Access Compliance Report Public Rights-of-Way (Curb Ramps)

Main Street: STANTON_AVE Cross Street: STANBROOK_DR Location: SW

ADA ID: RPAT210921122337 Ramp Type: Type 1 - Perpendicular Diagonal Initial Pass/Fail: Fail Overall Compliance: No Severity Score: 15

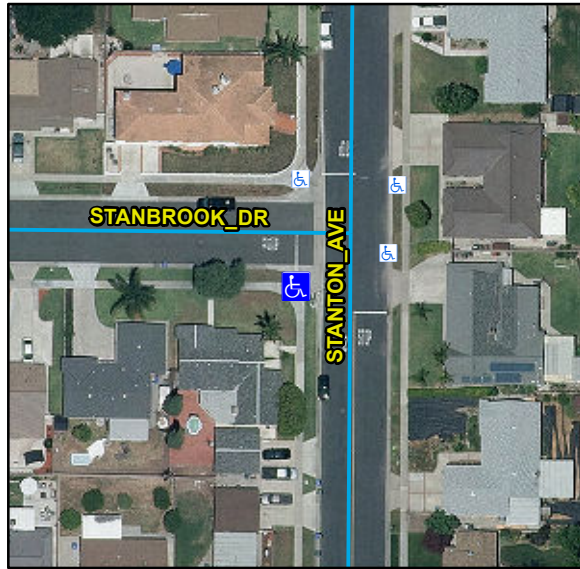
Compliance	Description	Data	Compliance	Description	Data
N/A	Ramp Length (in)	85	N/A	Flare Type LT	
Yes	Ramp Width (in)	48			N/A
No	Ramp Run Slope (%)	8.9	N/A	Flare Slope LT (%)	N/A
Yes	Ramp Cross Slope (%)	0.6	N/A	Flare Traversable LT	N/A
N/A	Landing Present	N/A	N/A	Flare Type RT	
N/A	Landing Length (in)	N/A			N/A
N/A	Landing Width (in)	N/A	N/A	Flare Slope RT (%)	N/A
N/A	Landing Run Slope (%)	N/A	N/A	Flare Traversable RT	N/A
N/A	Landing Cross Slope (%)	N/A	N/A	DWS Provided	N/A
N/A	Landing Movement Obstructed?	N/A	N/A	DWS Contrast	N/A
	Landing Movement Type	N/A	N/A	DWS Length (in)	N/A
N/A	Landing Shared	N/A	N/A	DWS Full Width	N/A
N/A	Clear Space	Yes	N/A	DWS Offset Left (in)	N/A
N/A	Clear Space To Crosswalk (in)	N/A	N/A	DWS Offset Right (in)	N/A
N/A	Marked Crosswalk 1	No	N/A	Marked Crosswalk 2	No
	Crossing 1 Direction	E		Crossing 2 Direction	N
	Marked Crosswalk 1 Width (in)	N/A		Marked Crosswalk 2 Width (in)	N/A

N/A	Ramp Inside Crosswalk 1	N/A	Yes	Ramp Inside Crosswalk 2	N/A
	Crossing 1 Slope (%)	6.3		Crossing 2 Slope (%)	2.5
	Crossing 1 Cross Slope (%)	0.8		Crossing 2 Cross Slope (%)	2.3
N/A	Gutter Ponding	N/A	N/A	Curb Slope	2.8
Yes	Gutter Lip Height (in)	0		Road Run Slope (%)	1.4
N/A	Gutter Run Slope (%)	N/A		Road Cross Slope (%)	0.1
N/A	Gutter Cross Slope (%)	N/A			
Yes	Overall Surface Condition: Acceptable		Yes	Perp Joint Present	Yes
	Cross Gutter Present?	Yes		Spandrel Present?	Yes
	Replace Cross Gutter?	No		Replace Spandrel?	No

Remove & Replace Curb Ramp With Two New Directional Ramps or Equivalent.

R304.2.2, STD 1115
